September 8, 2021
IAAC Registry Project #: 005694

Reference: Valentine Gold Project – Project Refinements

**Valentine Gold Project: Project
Refinements, Supplemental
Information**

Figure 1.1 Updated Project Layout and Comparison to EIS Site Layout

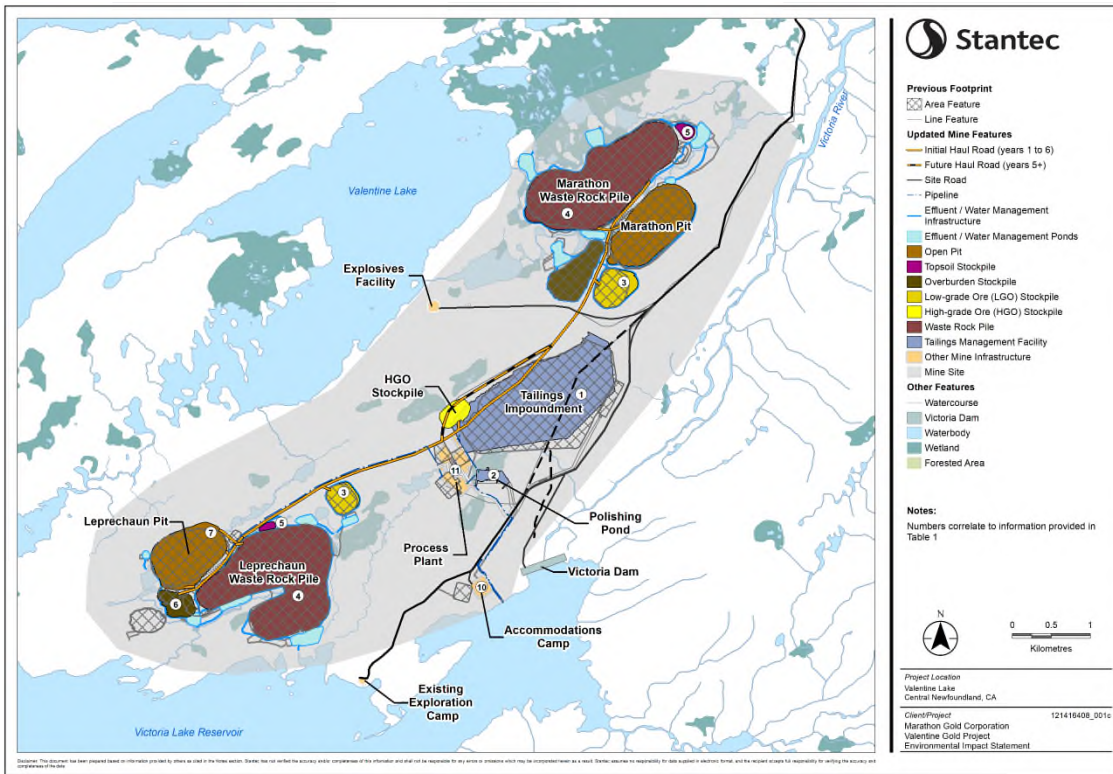
| Corresponding # on Figure 1.1 | Project Refinement | Rationale for Refinement |
|---|---|--|
| 1 | The tailings impoundment dam alignment has been altered and the footprint of the tailings impoundment has been reduced by approximately 5 hectares (ha) (approximately 3%). | The dam alignment has been shifted slightly, primarily along the south and east dam areas, in order to optimize the design (improve tailings storage efficiency without changing the dam height), improve dam safety, and entirely avoid the small stream running along the southern end of the impoundment. The footprint of the TMF has been reduced slightly, and the overall dam safety has been improved due to the new dam alignment following flatter topography. |
| 2 | The polishing pond has been relocated closer to the process plant area. | Relocation of the polishing pond results in several improvements: <ul style="list-style-type: none"> • Reduces the potential effects of a tailings impoundment dam breach in the former pond location (toe of dam to the east of the TMF) • Reduces piping lengths between the process plant and polishing pond, and eliminates pipelines along the crest and downstream slope of the tailings impoundment dam • Proximity to process plant improves accessibility for monitoring and surveillance |
| 3 | Low-grade ore stockpile footprints have increased (by approximately 1 ha or 10% for Leprechaun and approximately 3 ha or 21% for Marathon). | Increase in footprint of 10 to 20% due to an increase in overall ore extraction and life of mine based on the increased gold price. Stockpile remains in same location with a perimeter expansion to account for additional ore rock and to provide stream/waterbody buffers/setbacks. Water Management through perimeter drains to collection ponds remains the same. |
| 4 | Minor changes to the waste rock pile footprints (Marathon has increased by approximately 2 ha or 2% and Leprechaun has decreased by approximately 8 ha or 5%). | Minor changes have been made to the Marathon waste rock pile footprint to provide additional distance (buffer) between the toe of the pile and fish habitat along the southeast side of the pile, and to address topography and geotechnical data collected in 2020. There is an overall increase in footprint of approximately 2 ha. The Leprechaun waste rock pile footprint (perimeter) has been modified slightly to provide consistent buffers to fish habitat. Overall, the footprint has been reduced by approximately 8 ha. |

| Corresponding # on Figure 1.1 | Project Refinement | Rationale for Refinement |
|--|---|--|
| 5 | Minor relocation of topsoil stockpiles (approximately 440 m northeast for Leprechaun and 315 m north for Marathon) and footprints increased (approximately by 0.06 ha for Leprechaun and approximately 0.55 ha for Marathon). | The Leprechaun topsoil stockpile has been relocated a short distance east due to a change in the ramp/access for Leprechaun pit and to improve water/seepage management for this pile. The increased footprints are related to increased volume of topsoil based on improved delineation from advanced geotechnical studies. The Marathon topsoil stockpile has been relocated a short distance north to provide more buffer between the pond and the adjacent stream, and to improve ditching and water management in this area. |
| 6 | The Leprechaun overburden stockpiles were combined and the overall footprint decreased (approximately 3 ha or 19%). No changes to the Marathon overburden stockpile. | The Leprechaun overburden stockpiles (originally two stockpiles) have been combined into one and the overall footprint has been reduced by nearly 20%. This change was made due to the discovery (through ground-truthing) that the stream located between the piles was further west than presented on provincial mapping. As a result, a single stockpile design was possible to the east of the stream, which also reduces the overall footprint of the pile and reduces water management infrastructure. |
| 7 | The Leprechaun pit slope and perimeter has been adjusted slightly along the southwest and northeast crests, resulting in an increased footprint (approximately 6 ha or 11%). No changes to the Marathon open pit. | Further pit slope assessments have determined that a minor flattening of the pit slope is required along the southwest portion of the pit, and the pit ramp has been adjusted to exit in the northeast/east portion of the pit. |
| 10 | The accommodations camp (pad) has been relocated approximately 245 m northeast. | The accommodations camp has been rotated and shifted approximately 245 m northeast to reduce earthworks requirements and potential effects to an adjacent, small wetland. There is no change in the size of the camp. |

| Corresponding # on Figure 1.1 | Project Refinement | Rationale for Refinement |
|--------------------------------------|---|--|
| 11 | The process plant / mine services layout has been changed. | The layout / arrangement of the process plant and mine services area has been altered to address water management and health and safety related issues, as well as engineering optimization. The overall footprints are approximately the same as presented in the EIS. The design of selected point sources (dimensions and orientations of release stacks / vents) at the processing plant was updated to reduce effects to the atmospheric environment. |

FIGURE
2.1

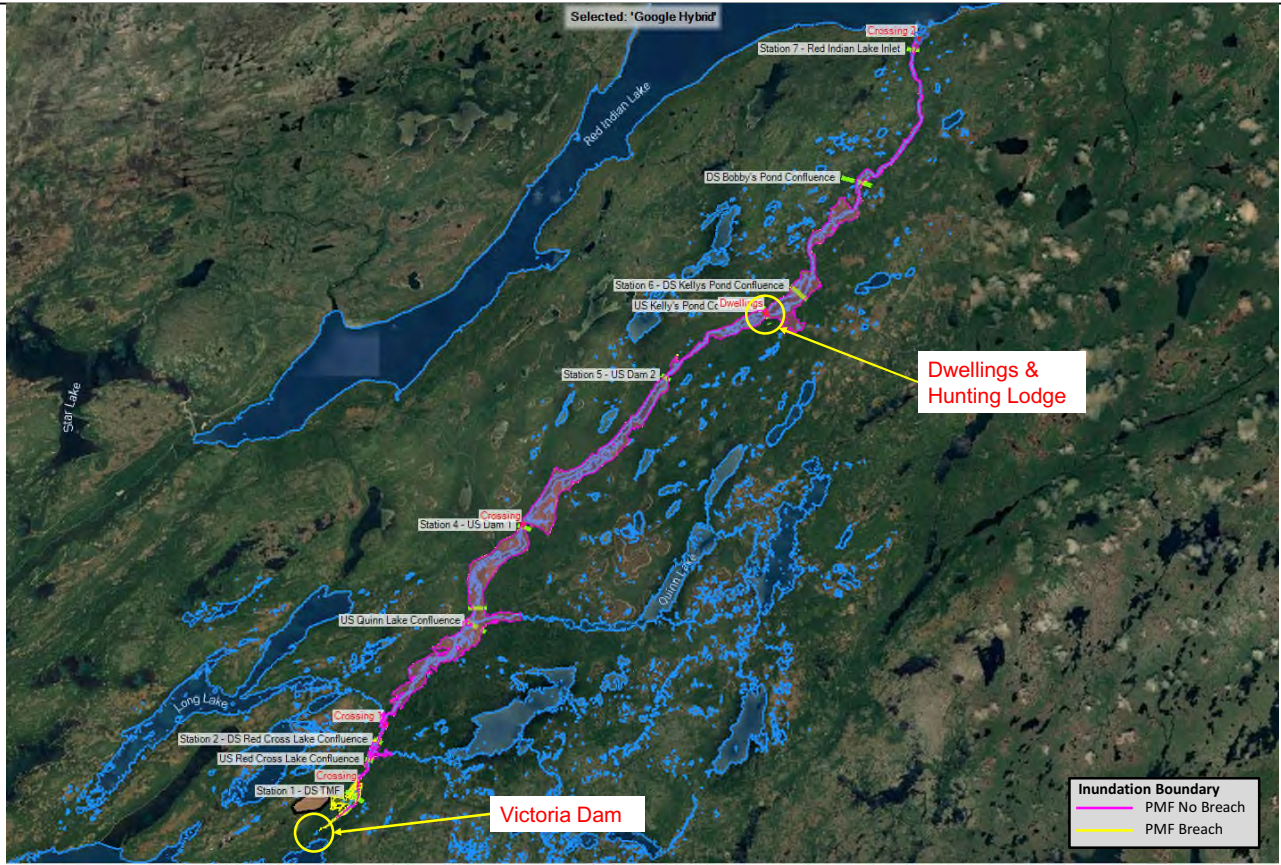
At this time, the flood-induced dam breach model runs have been completed. Figures 2.1 to 2.3 show the inundation extent under the 450 mm probable maximum flood (PMF) in the Victoria River, with (pink) and without (yellow) a dam breach. In the event of a dam breach under a PMP induced flood, up to a peak discharge of 1,735 m³/s may be released from the TMF. This is approximately 8% to 16% lower than the peak discharge estimated in the DBA presented in the EIS, as a result of ongoing design refinements including relocation of the polishing pond. The incremental impact upstream and downstream of the TMF was assessed relative to the impact of the PMF.
